AGENDA REPORT

Case No. ARB1709-01 **Phone**: 512-990-6300

SUBJECT: Discuss and consider an application for an Architectural Waiver to allow for an

additional increase in the amount of permitted accent materials with the use of Exterior Insulation Finishing Systems (E.I.F.S.) up to 44% and to permit E.I.F.S. within the first nine (9) above finished grade for the Pflugerville Hospital.

North - Rear Elevation

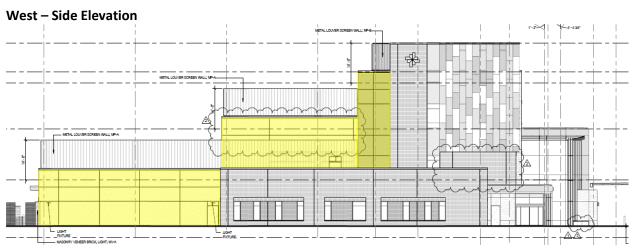
PROPOSED BUILDING ELEVATIONS: (Areas shown in yellow represents where E.I.F.S is proposed.)

Staff is generally more favorable to stucco due to its durability and longevity, rather than E.I.F.S. However, if E.I.F.S is permitted through the proposed architectural waiver, staff recommends the following conditions:

- 1. Limit E.I.F.S to a certain percentage
- 2. All E.I.F.S shall be installed with heavy duty mesh reinforcement regardless of location on the building to ensure more impact resistance.
- 3. E.I.F.S shall be designed as a drainable system
